TABLE T. S. 3.1-2
REACTOR COOLANT SYSTEM PRESSURE ISOLATION VALVES

b. HEATUP AND COOLDOWN LIMIT CURVES FOR NORMAL OPERATION

Figure TS 3.1-1
 Proposed Amendment 46
 8/7/81

Figure TS 3.1-1 Kewaunee Reactor Coolant System Heatup Limitations Applicable for Periods up to 10 Effective Full Power Years. Margins of 60 PSIG and 10°F are Include for Possible Instrument Error

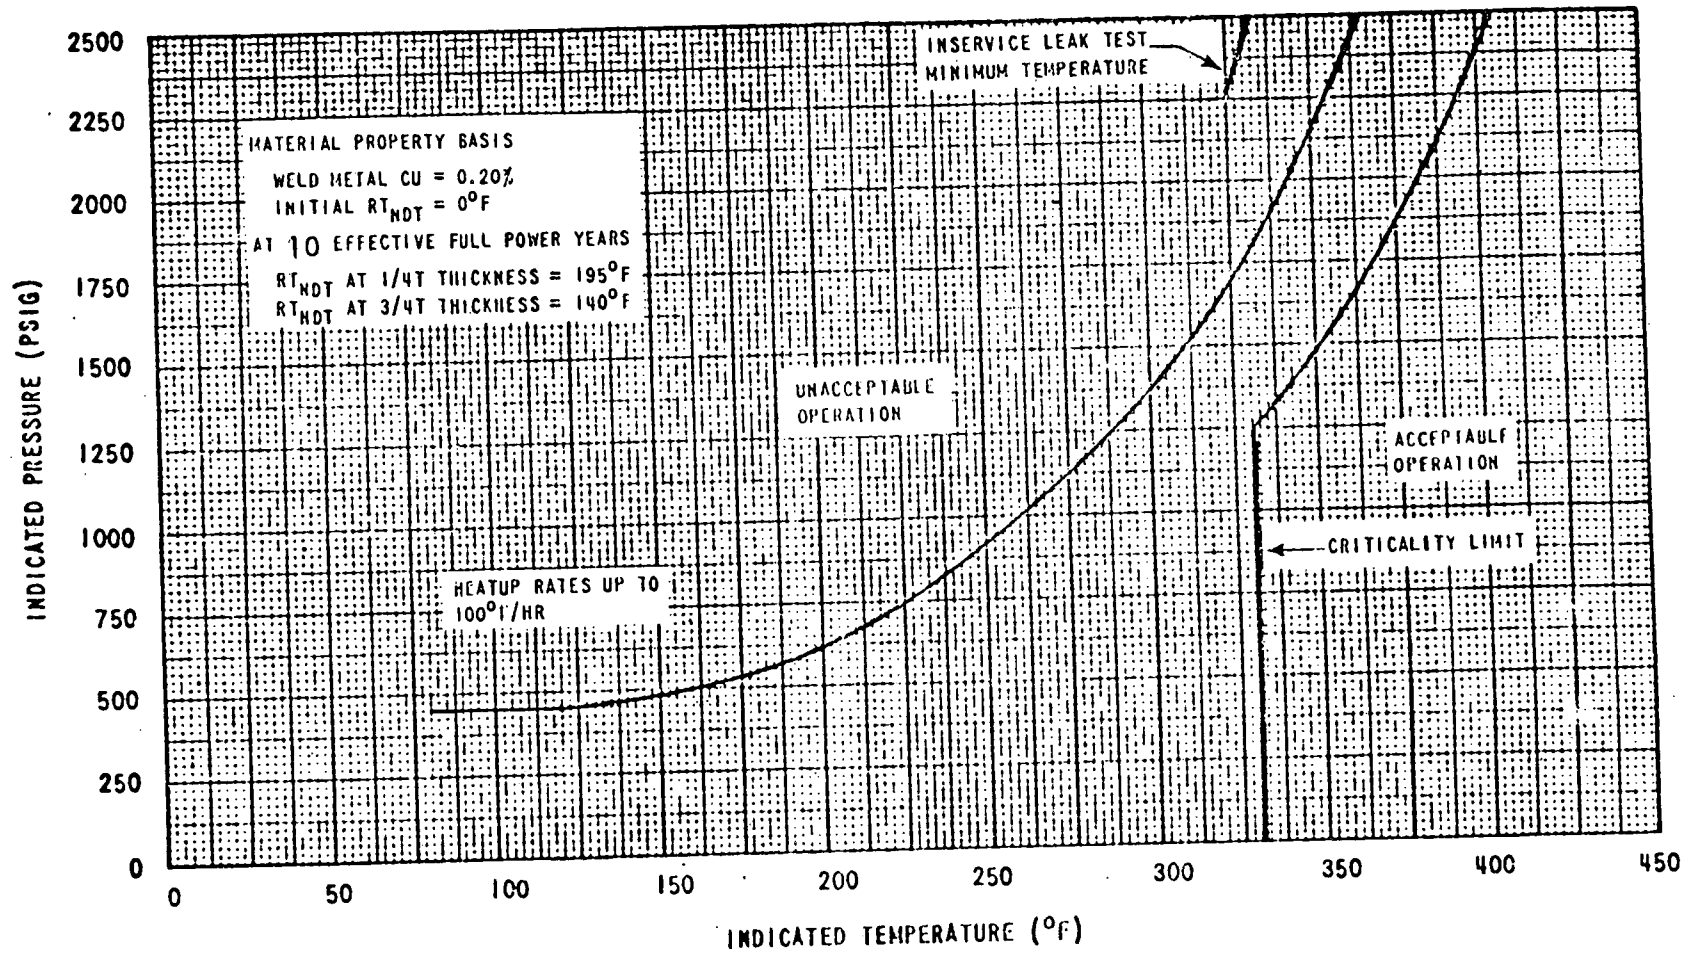
1. The reactor coolant temperature and pressure and system heatup and cooldown rates (with the exception of the pressurizer) shall be limited in accordance with Figures TS 3.1-1 and TS 3.1-2 for the service period up to 10 equivalent fullpower years. | 46

- a. Allowable combinations of pressure and temperature for specific temperature change rates are below and to the right of the limit lines shown. Limit lines for cooldown rates between those presented may be obtained by interpolation.

- b. Figures TS 3.1-1 and TS 3.1-2 define limits to assure prevention of non-ductile failure only. For normal operation other inherent plant characteristics, e.g., pump heat addition and pressurizer heater capacity may limit the heatup and cooldown rates that can be achieved over certain pressure-temperature ranges.

The results of Irradiation Capsules V and R analyses are presented in WCAP 8908 and WCAP 9878, respectively. Heatup and cooldown limit curves for normal operation of the reactor vessel are presented in Figures TS 3.1-1 and TS 3.1-2 and represent an operational time period of 10 effective fullpower years.

Figure TS 3.10-7

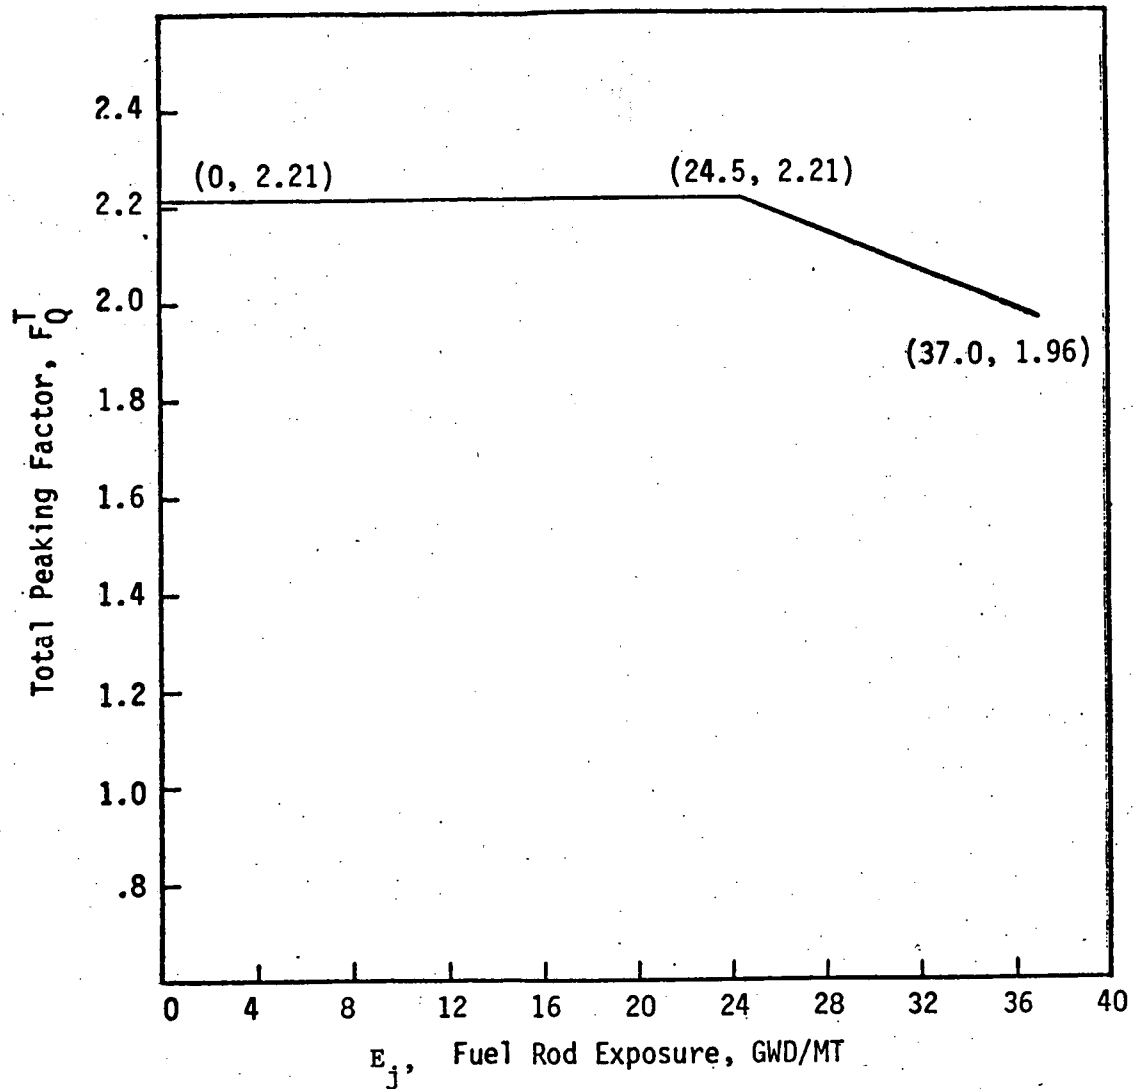
$$F_Q(Z) \leq F_Q^T(E_j) \times K(Z) \text{ for } P > .5$$

$F_Q^T(E_j)$ is the function given in Figure TS 3.10-7

The $F_Q(Z)$ limits of specification 3.10.b.1.a include consideration of off-gassing effects in fuel manufactured by Exxon Nuclear Company. References 7 and 8 discuss this phenomena. Since the fission gas release becomes enhanced as burn-up increases,

an additional penalty in the form of the function $BU(E_j)$, as shown in Figure TS 3.10-7, is applied to Exxon fuel.
